From:	Catherine Brimble Senior Landscape Officer		
Service	WBC Landscape and Trees	App No:	252320
Address:	Bismillah House, Brookers Hill, Shinfield, Wokingham, RG2 9BX.		
Proposal:	Application for submission of details to comply with the following condition of planning consent 222154 dated 31/10/2022. Condition 2 relates to a scheme of landscaping.		
Type of Development:			
Site Visit Made:	Yes/No

Condition 2 – Scheme of landscaping

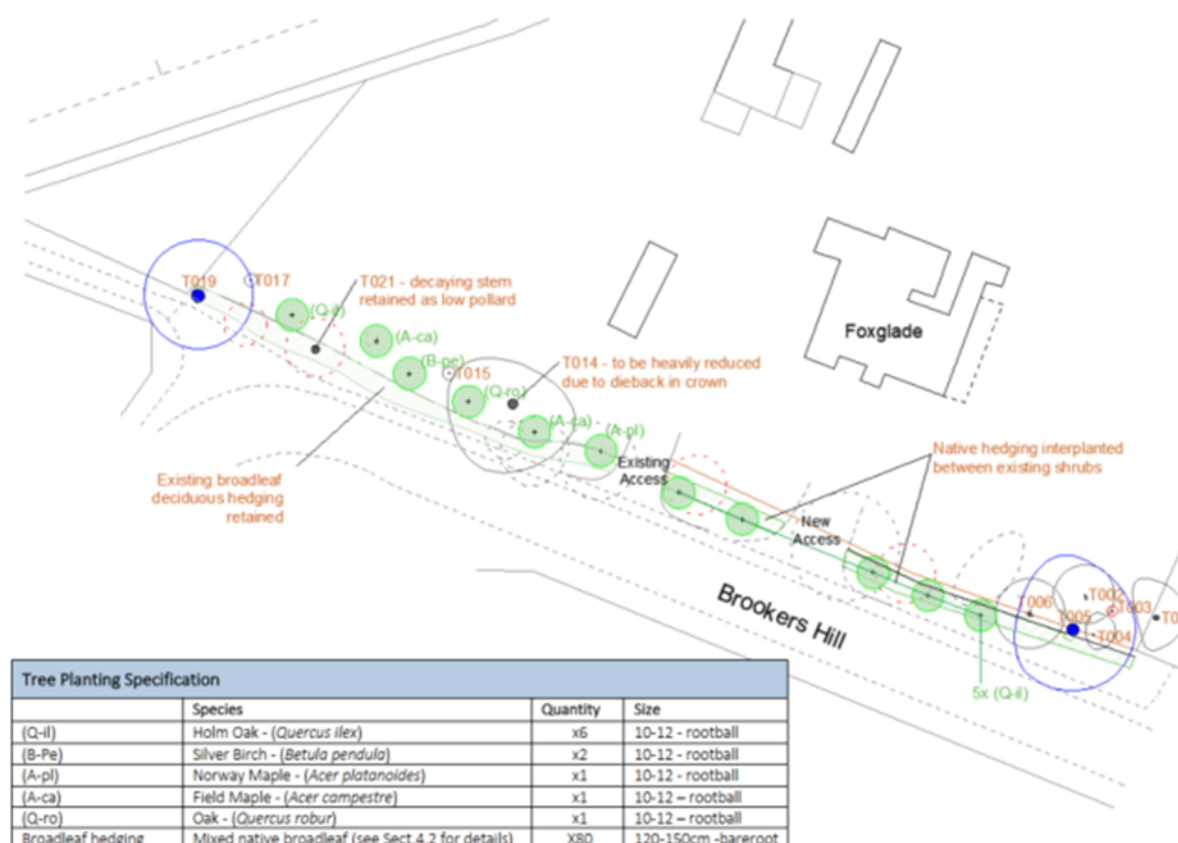
It is not entirely clear from the limited details provided on the Landscape Plan which are the existing trees, and which is the proposed new planting. All existing vegetation will need to be indicated as 'existing' and presume that some of the planting shown on the eastern boundary is also existing which is shown coloured black or grey.

I note from the site photos associated with the original application (243135) that the some of the Laurel and Privet hedging has already been planted however the proposed planting along the front boundry of the site, the fruit orchard and Hazels do not appar to have been planted at the time the photos were taken (Feb 2025). If these have since been planted then the applicant will need to provide further photos to show this new planting.

The proposed fruit orchard appears to be located in an area of hardstanding (this is unconsented and extends further than the approved area identified on plans for 222154) and therefore this will need to be removed to allow for the trees to be planting in this area, and details of how this will be achieved indicated on the drawing.

Works to TPO trees on the site were consented at the end of November 2022 and as part of this approval 11 new replacement trees plus broadleaf hedging was required to be planted, an extract of the required planting is shown below. The photos taken in February 2025 don't appear to show this planting either.

The Landscape Plan will need to be updated to show planting as either existing, recently planted or proposed, Full details of the plants will need to be given showing full species name, numbers and size of trees or shrubs at time of planting. The planting plan will also need to include the details of the required replacement planting in relation to the condition for the removal of TPO trees under application 223088 – see above. All planting will need to be undertaken this planting season (End of October – Early March). I suggest a Landscape Architect is commissioned to provide the information as required.
